ADVANCED WASTEWATER TREATMENT FACILITY (AWWT) IMPLEMENTATION PLAN FOR ABOVE-GRADE DECONTAMINATION AND DISMANTLEMENT

**FERNALD CLOSURE PROJECT
FERNALD, OHIO**

DOCUMENT CONTROL NO. 1789-PL-0007 (REV. 0) PCN1

<u>DATE</u>	<u>REVISION NO.</u>	<u>DESCRIPTION AND AUTHORITY</u>
3/15/05	Rev. 0	Issued Final Implementation Plan
4/26/05	PCN1	Per USEPA comments, changes incorporated into the Notation page, Figures 1-1 and 2-1 and Subsections 1.2, 2.2, 2.3.2, 2.3.4, 2.4, 2.5.1, 2.5.2 and 4.0.

FIGURE 2-1 Air Monitoring Locations PCN1

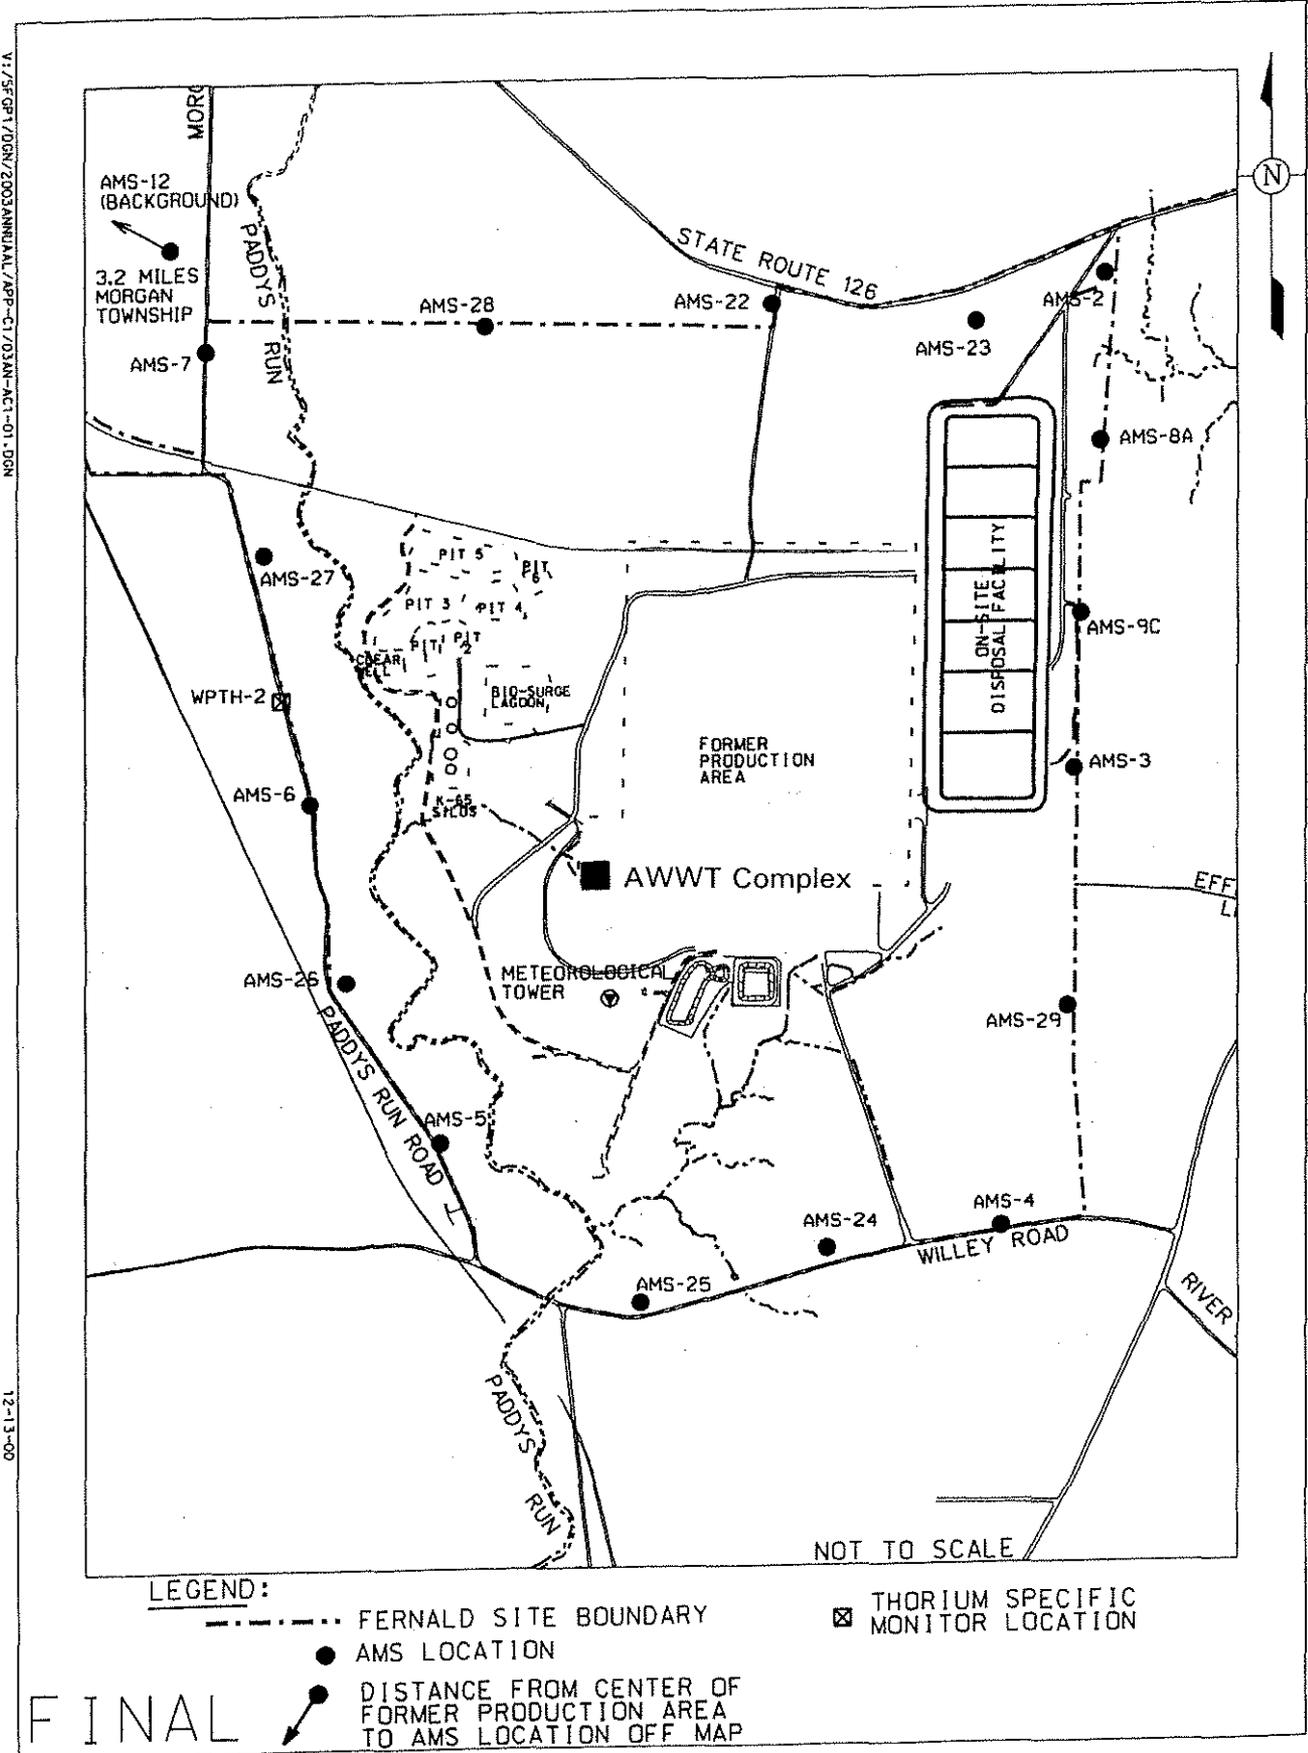
Environmental radiological air monitoring during the D&D of the AWWT Complex will consist of the Fernald Site Environmental Monitoring Program described in the site-wide IEMP, and discussed in Sections 3.5.1 and 3.6.2.1 of the OU3 Integrated RD/RA Work Plan. FCP boundary monitors are shown in Figure 2-1.
